May 13, 1985

ST-HL-AE-1239

South Texas Project  
Units 1 & 2  
Docket Nos. STN 50-498, STN 50-499  
Notes from Review Meeting with  
Instrumentation & Controls Systems Branch

HANDOUT FOR ITEM 30

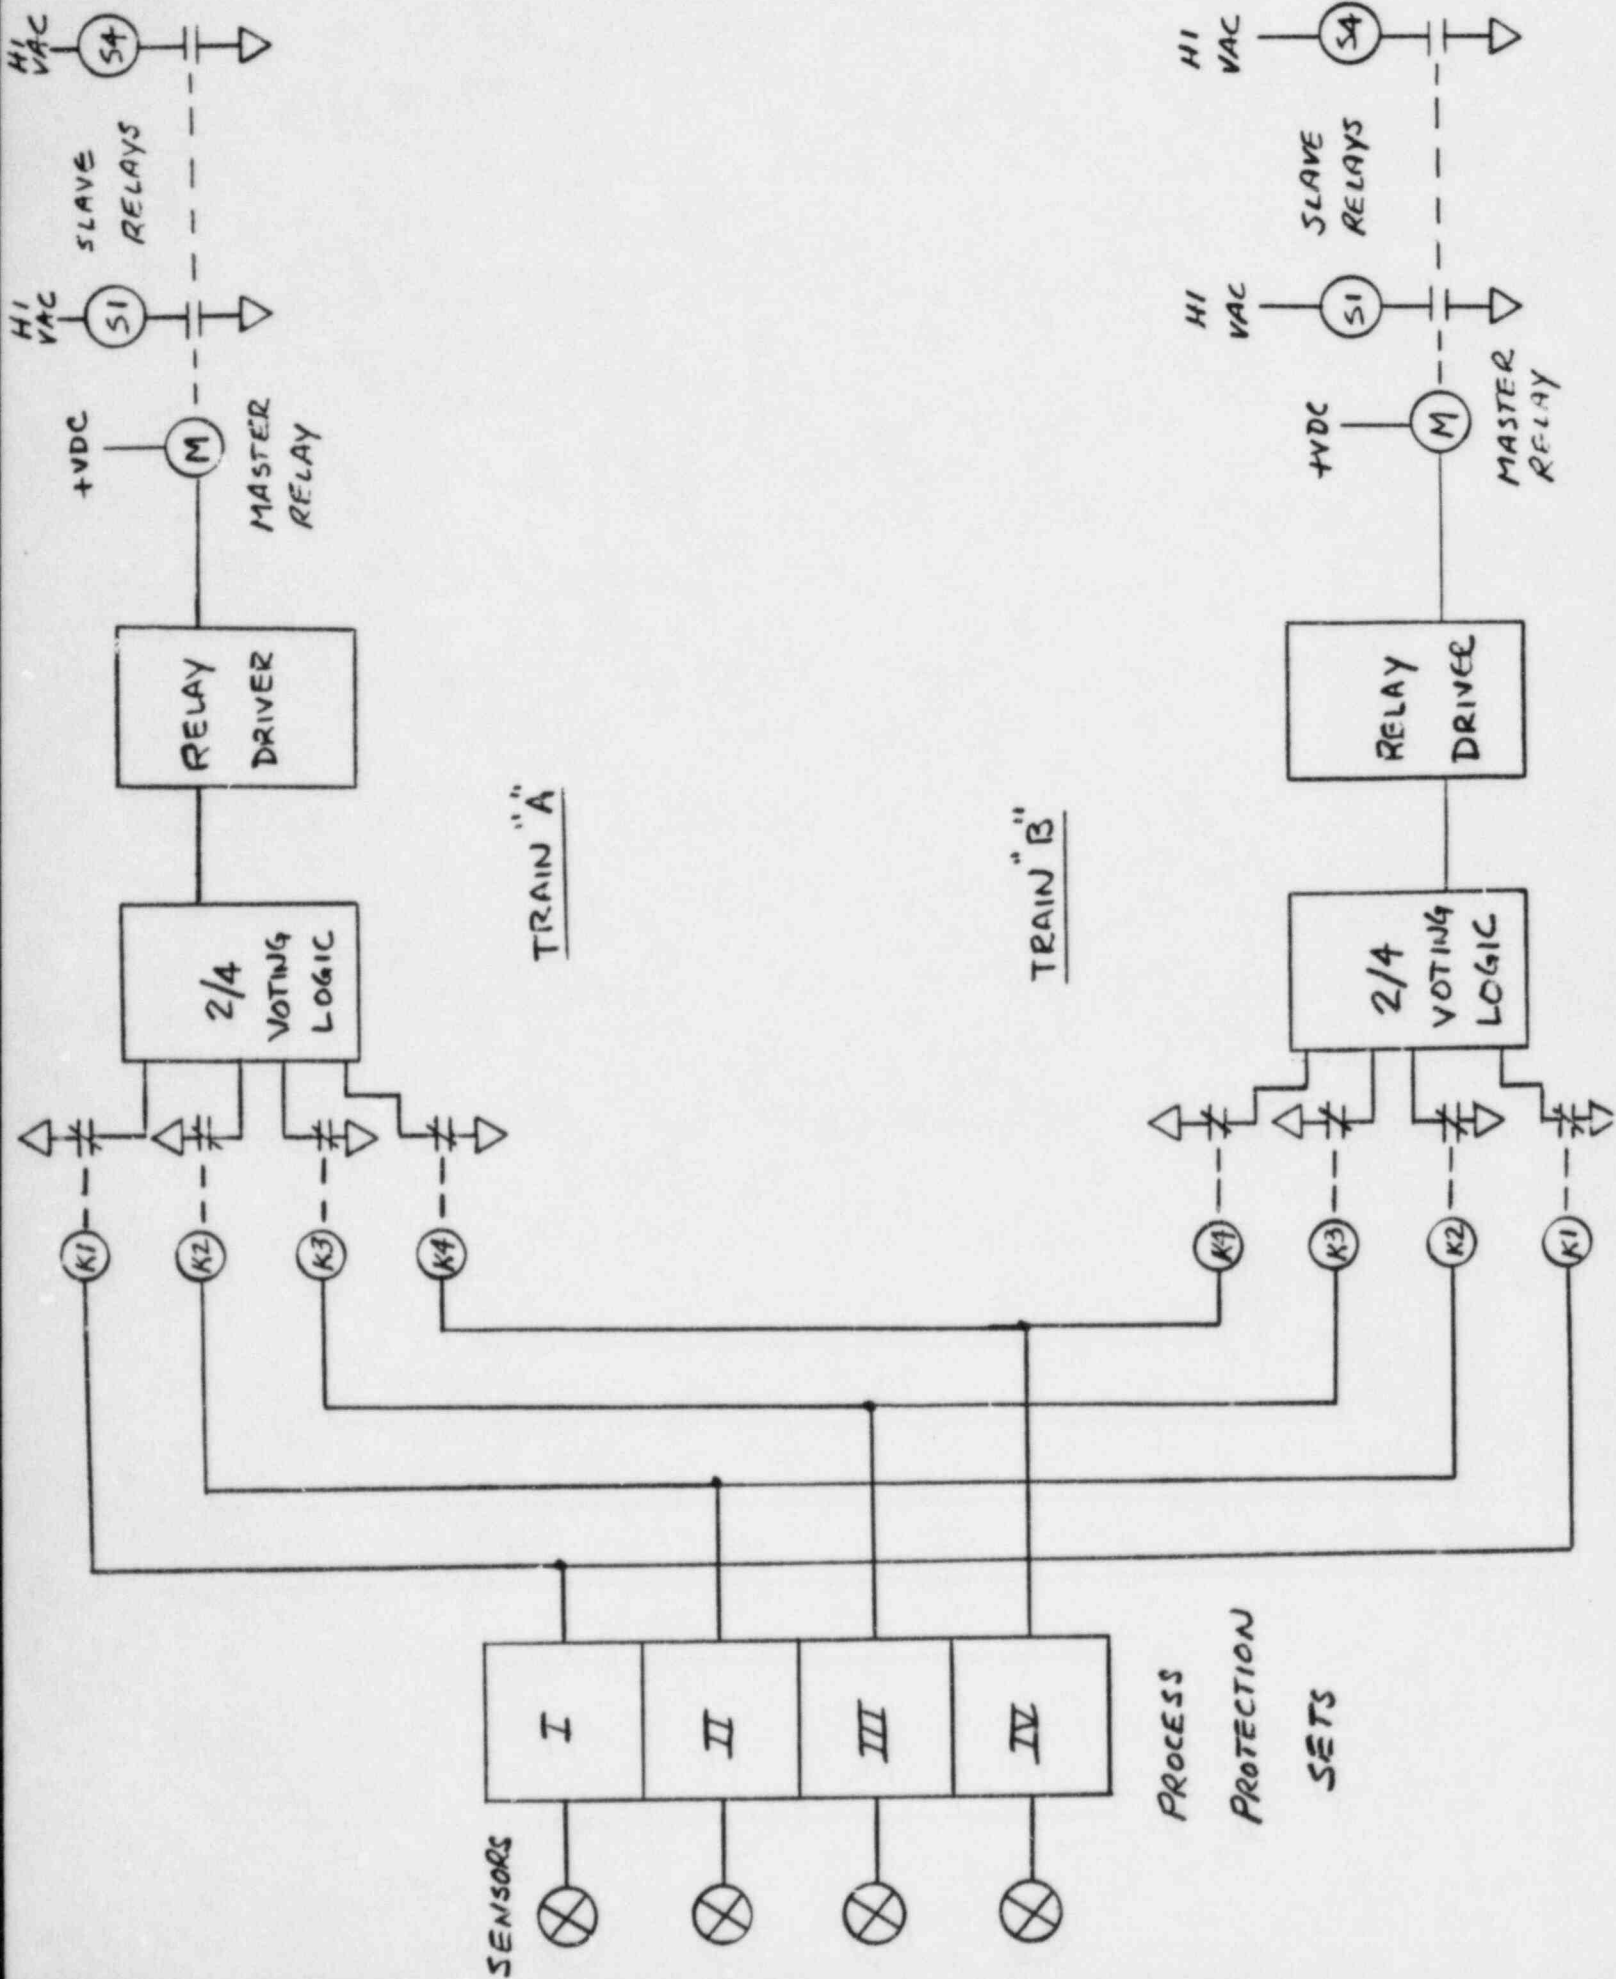
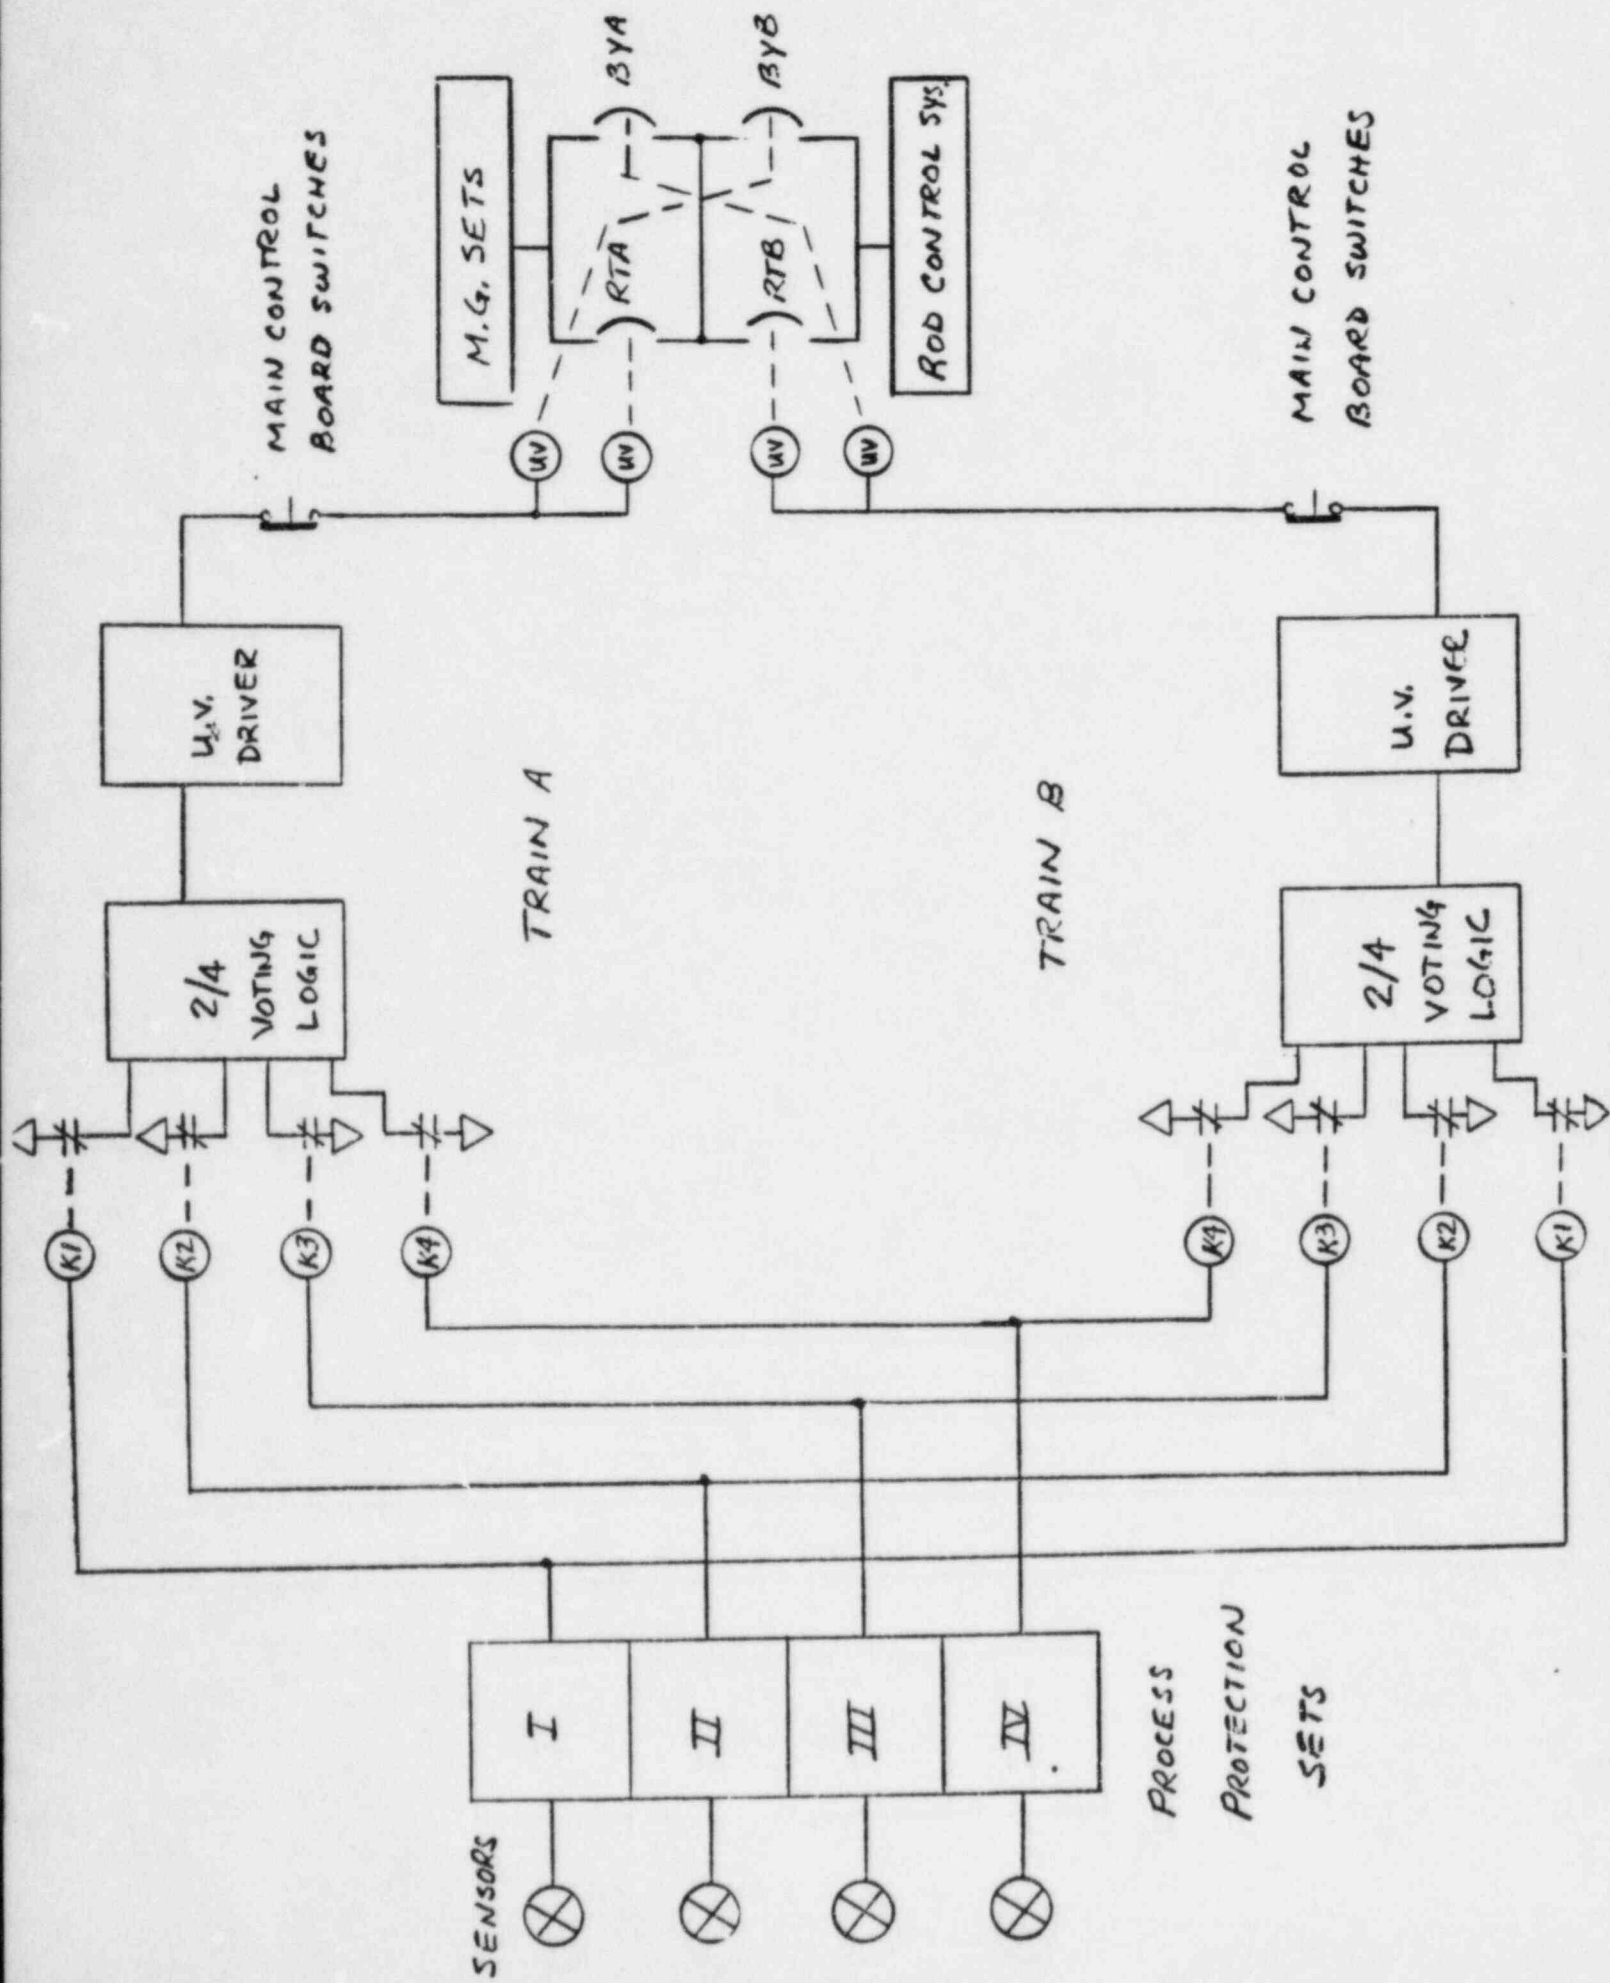
30. Provide Failure Modes and Effects Analyses on the ESFAS as  
(7.3) by R.G. 1.70 "Standard Format and Content of FSAR". Please note that the FMEA of the ESFAS should be addressed on actuation system including the NSSS & BOP scope of supply. The interfaces with power sources, instrument air system and the cooling water system to vital equipment should also be addressed. In Amendment 41 Section 7.3.2.1, there was a statement on this subject, however, in Amendment 43, that section and Tables 7.3-12, 13 and 14 were deleted. The staff finds that this further deviates from the R.G. 1.70 requirements.

Concern The ICSB raised a question concerning WCAP's on the FMEAs which relate to 2 train (not 3 train) design being applicable to STP. The NRC requested additional 3 train information.

Westinghouse subsequently addressed the question of FMEA WCAP applicability to STP. Using overviews (handout), Westinghouse reviewed the 2 train SSPS design for safeguards components and for reactor trip breakers. For STP, the reactor trip function is handled in the same way, except  $R = A$  and  $S = B$ . For safeguards components, the voting logics in R and S each drive up to 3 relay drivers, one for each actuation train (A, B and C). The relay drivers then interface with master relays, which then interface with slave relays. Reliability is improved in that testing of a logic train leaves all 3 actuation trains operable; testing of an actuation train leaves both logic trains and the other actuation trains operable.
